20 September 2022
Our Ref: 21BRT0549
Your Ref: DEV2022/1310

RE: 15 Nexus Way Southport, Traffic Response to Further Issues

TTM has been engaged to respond to further issues letter for a proposed health care use at the above address. This request from Economic Development Queensland is dated 9 September 2022 and refers to Application Number DEV2022/1310.

PROJECT
HILL STREET, SOUTHPORT
DRAWING TITLE
**VEHICLE ACCESS ARRANGMENTS
SWEEP PATH ANALYSIS**

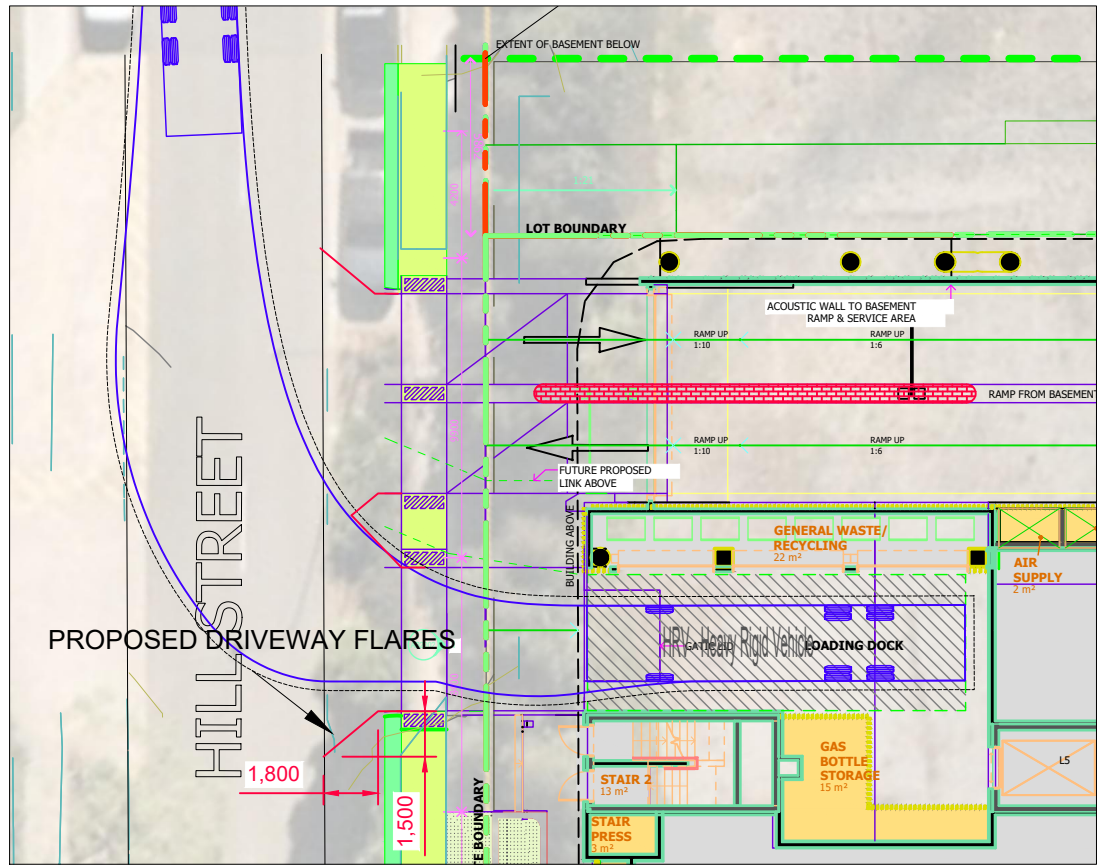
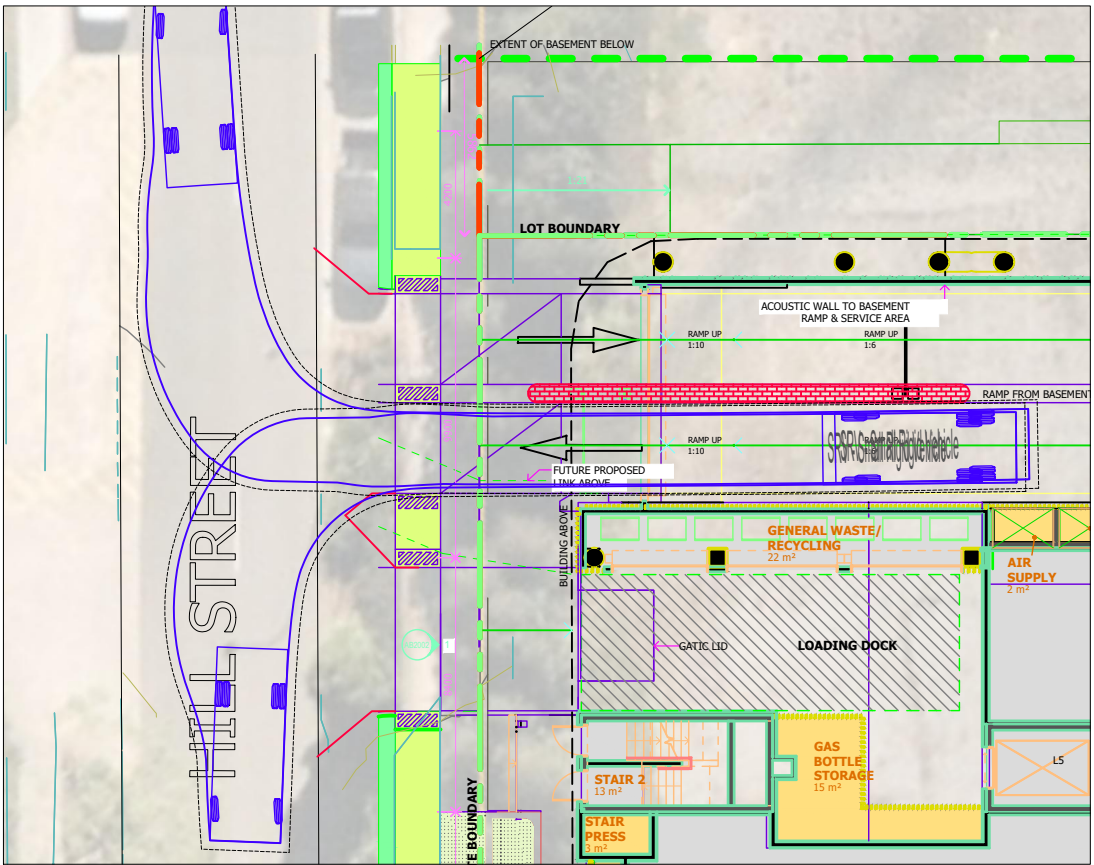
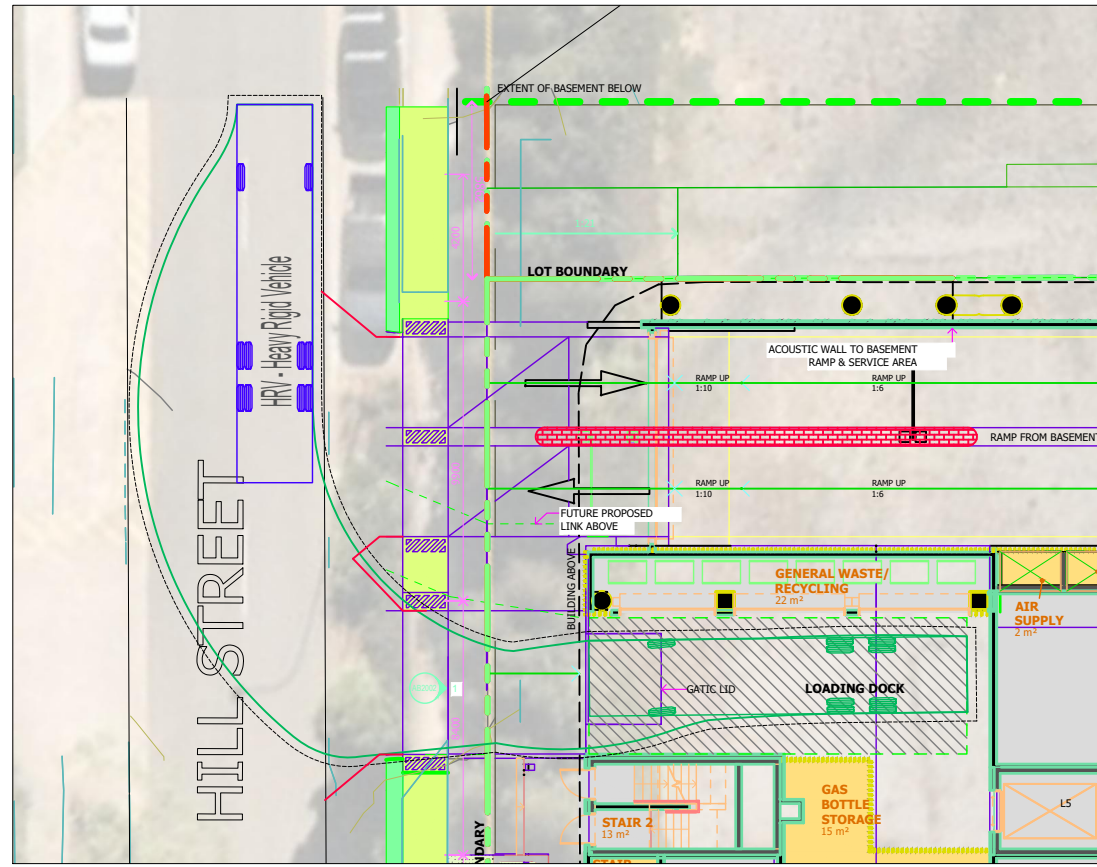
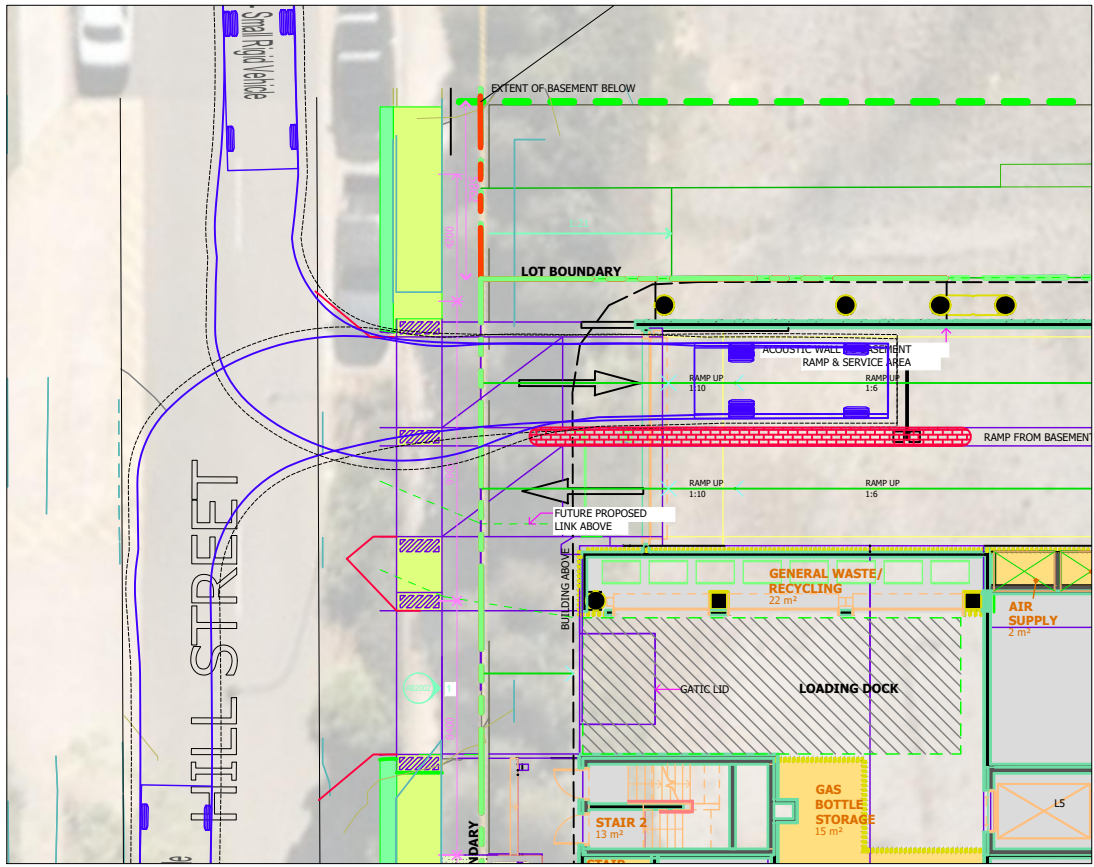
Item 3(g) of the EDQ letter requests swept paths of the largest vehicle accessing this loading bay.

Item 3(h) of the EDQ letter requests the vehicle cross over is shown to demonstrate vehicle swept path are contained.

Consistent with the response to item 3(f) the swept path for a HRV is shown in **Appendix B**.

All swept paths shown in **Appendix B** identify the edge of the access, allowing for 1500mm by 1800mm tapers. The exception to this will be the exit taper from the service bay to allow for larger vehicles to turn right from the site.
